Permit Number 2020-P-1278-FP
Job Address: Near southeast corner of FM 973 & Blake Manor Road, Manor, TX. 78653

The first submittal of the Lagos Phase 2 Final Plat (*Final Plat*) submitted by Kimley-Horn and received on March 04, 2021, have been reviewed for compliance with the City of Manor Subdivision Ordinance 263B.

**RE: 2020-P-1278-FP
Lagos Manor Phase II Final Plat
Near southeast corner of FM 973 & Blake Manor Road, Manor, TX 78653**

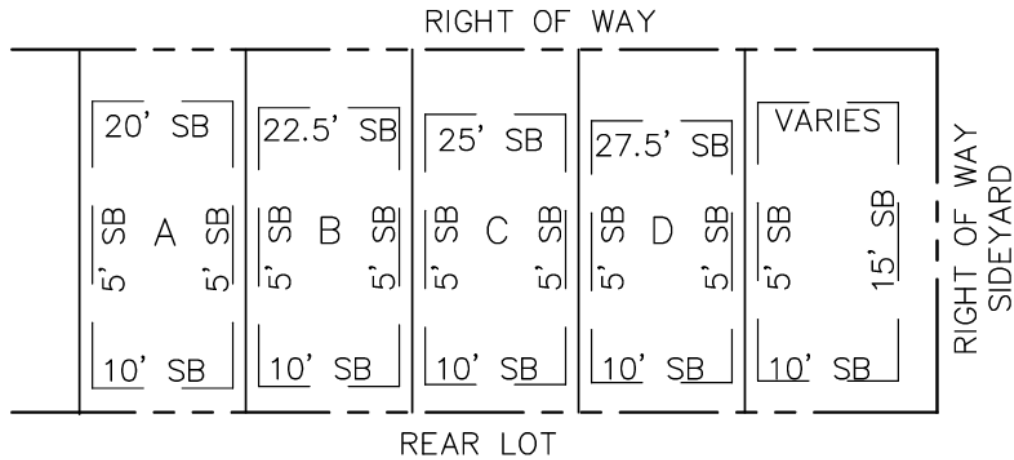
11. True bearings and distances to the nearest established street lines, official monuments, or existing subdivision corner which shall be accurately described on the plat and rotated to the state plane coordinate system. Using said system, X and Y coordinates shall be identified for four (4) property corners. The comment response letter stated this was addressed but the information could not be located on the plat.

Response: Please see the updated plat.
